PARTS & SERVICE NEWS

REF NO. AA01025

DATE February 1, 2001

- SUBJECT:** PAYLOAD METER II SUSPENSION PRESSURE SENSOR KIT (AK4599)
- PURPOSE:** To inform the field of kit (AK4599) that replaces the Payload Meter II suspension pressure sensor (PC0310).
- APPLICATION:** Komatsu Electric Drive Dump Trucks that are presently using suspension pressure sensor (PC0310)
730E: AFE47-A & Up, A30079 & Up;
830E: AFE32-A & Up, A30544 & Up;
930E: AFE48-A & Up, A30019, A30026 & Up
- FAILURE CODE:** 7P72Z9
- DESCRIPTION:** This bulletin contains information regarding the replacement of a failed Payload Meter II suspension pressure sensor.

FIGURE 1. SUSPENSION PRESSURE SENSOR (PC0310)
1. Pressure Sensor (PC0310) 3. Valve Assembly (TZ8627)
2. O-Ring (0700-51009) 4. Schrader Valve (TD7179)

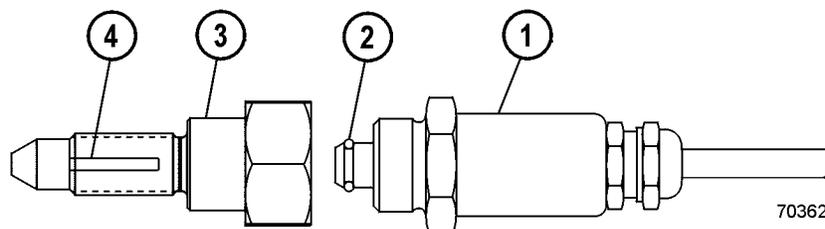
A new kit has been developed to replace a failed Payload Meter II suspension pressure sensor (PC0310). Suspension pressure sensor (PC0310) is mounted to the suspension cylinder using valve assembly (3, Figure 1), that contains Schrader Valve (4). The sensor can be replaced without releasing the nitrogen charge in the suspension.

Make certain that only sensor (1, Figure 1) is removed from valve assembly (3). Removing the complete valve assembly (3) will result in the component being forced out of the suspension by the nitrogen gas pressure inside the suspension.

FIGURE 2. SUSPENSION PRESSURE SENSOR (EF8669)

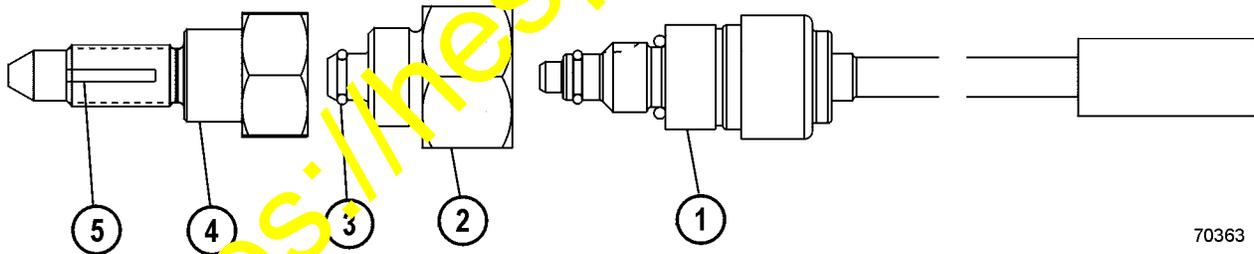
1. Thoroughly clean valve assembly (4, Figure 2) where the suspension pressure sensor had been.
2. Lubricate and install new O-ring (3) on adapter (2).

Do not install adapter (2) into valve assembly (4) unless sensor (1) is installed into adapter (2) first. Otherwise, nitrogen gas will escape from suspension under pressure.

3. Install pressure sensor (1) into adapter (2). Tighten sensor (1) to 23 ft. lbs. (31 N.m) torque.
4. Install the adapter / sensor assembly into valve assembly (4). Tighten adapter / sensor assembly to 22-29 ft. lbs. (30-39 N.m) torque.
5. Reconnect the electrical connections to the suspension pressure sensor.
6. Recalibrate the Payload Meter system as outlined below:
 - a. With the engine running and the truck stopped, press and hold the CAL/CLR switch until "CAL" is flashing on the payload meter display.
 - b. Drive the truck until the speed is approximately 5-10 MPH (10-15 Km/H)
 - c. Press the CAL/CLR switch once.
 - d. Drive the truck until the payload meter display switches back to the clock mode. This will take up to 30 seconds.
 - e. The payload meter is now calibrated and ready for normal operation.
